Havant Thicket Reservoir

Design and Access Statement Addendum

Main Reservoir Works Phase

Document Reference : HTR-FUW-ZZ-ZZ-PL-W-0056

Figure 4.1: Visualisations comparison – Viewpoint 12 (South-west Corner)

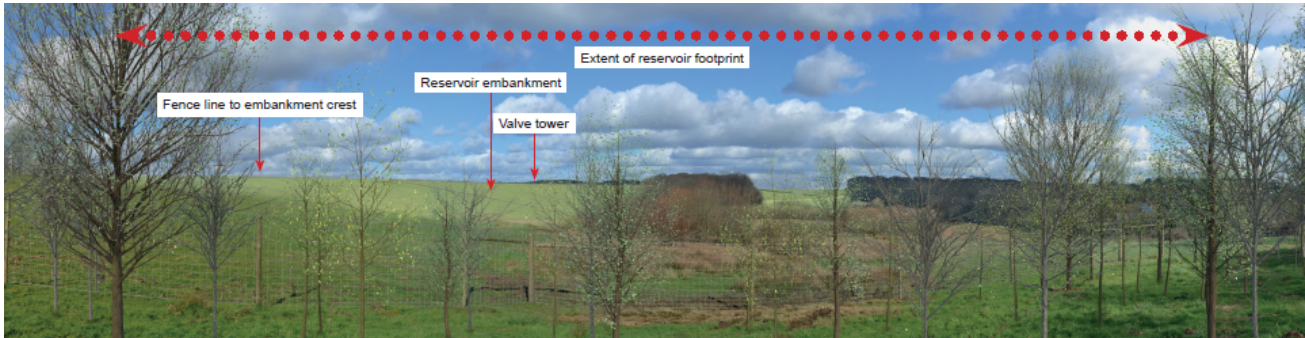
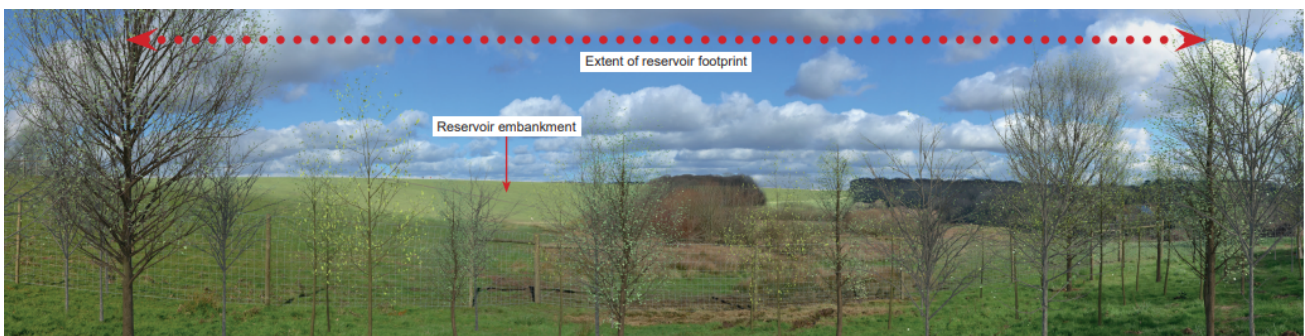
- 2.4. The slope angles have been redesigned from 1:5 to 1:7, to a more subtle range of 1:7 to 1:9.

- 2.5. For visitors and residents local to the reservoir, this design evolution will have minimal visual distinction from the design already granted planning permission, as the highest point of the embankment will remain at same elevation.

- 2.6. Due to the overall footprint of the reservoir decreasing, the most notable visual element of these amendments will be the increase in the landscaped areas of the site and the reduction in the surface area of the retained water. This reduction in the surface water area does not impact the projected water storage capacity.

The primary embankment features a maximum height of 20 meters, with a crest level measuring 40.5 meters above ordnance datum (AOD). Extending over a length of 2,800 meters, its inner slope varies between 1:7 and 1:8, while the outer slope predominantly ranges from 1:7 to 1:9.
